# UNITED STATES PATENT AND TRADEMARK OFFICE

APPLICATION NO.	FILING DATE	FIRST NAMED INVENTOR	ATTORNEY DOCKET NO.	CONFIRMATION NO.
10/534,260	05/10/2005	Naoki Sawada	XA-10354	4984
181	7590	03/15/2007	EXAMINER	
MILES & STOCKBRIDGE PC 1751 PINNACLE DRIVE SUITE 500 MCLEAN, VA 22102-3833			COKER, ROBERT A	
			ART UNIT	PAPER NUMBER
			3616	
SHORTENED STATUTORY PERIOD OF RESPONSE	MAIL DATE	DELIVERY MODE		
3 MONTHS	03/15/2007	PAPER

<b>Office Action Summary</b>	<b>Application No.</b>	<b>Applicant(s)</b>	
	10/534,260	SAWADA ET AL.	
	<b>Examiner</b>	<b>Art Unit</b>	
	Robert A. Coker	3616

## DETAILED ACTION

Figure A

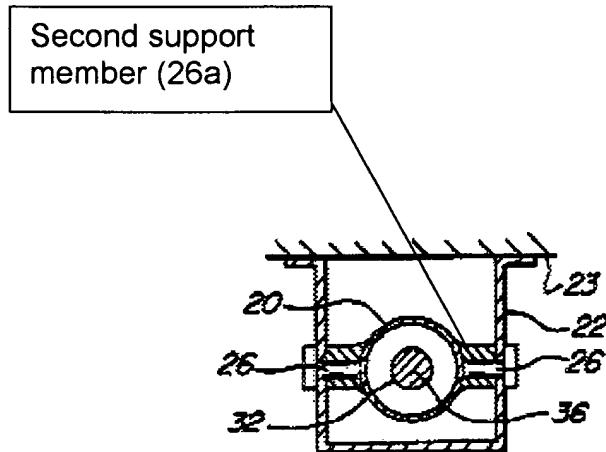
3. Claims 1 and 7 are rejected under 35 U.S.C. 102(b) as being unpatentable by Schoen et al., (U. S. 6,324,935).

With respect to claim 1, Schoen et al., discloses a steering apparatus for a vehicle, comprising: an upper bracket (12) fixed to a rear side portion of a vehicle body and including a pair of opposed flat plate portions formed with first holes opposed each other and separated from each other; a lower bracket (22) fixed to a front side portion of the vehicle body and including a pair of opposed flat plate portions formed with second holes opposed each other and separated from each other; a steering column (20) rotatably supporting a steering shaft (32); a first support member (16) held between said opposed flat plate portions of said upper bracket, formed with a first support hole opposing the first hole and supporting said steering column; a second support member (See Figure A) held between said opposed flat plate portions of said lower bracket, formed with a second support hole opposing the second hole and supporting said steering column; a first support mechanism (52) for supporting said steering column on said upper bracket via the first hole of said upper bracket and via the first support hole of said first support member; and a second support mechanism (26) for supporting said steering column on said lower bracket via the second hole of said lower bracket and via the second support hole of said second support member, an improvement characterized in that said steering column (20) is integrally formed with said first support member (16) and said second support member (See Figure A), said first support member is integrally formed with a first swelling portion having a pair of side portions that respectively press-abut on said pair of opposed flat plate portions of said upper bracket, and said second support member is integrally formed with a second swelling portion having a pair of side

portions that respectively press-abut on said pair of opposed flat plate portions of said lower bracket.

With respect to claim 7, Schoen et al., discloses a steering apparatus for a vehicle, comprising: a steering column (20) for rotatably supporting a steering shaft (32); and a vehicle-body-rear-sided bracket (12) and a vehicle-body-front-sided bracket (22), fixed to a vehicle-body-sided strengthening member (14, 23), for supporting said steering column, an improvement characterized in that said steering column is integrally formed with a plurality of swelling portions (26a, 44) and is supported on said vehicle-body-rear-sided bracket and/or said vehicle-body-front-sided bracket via said swelling portions.
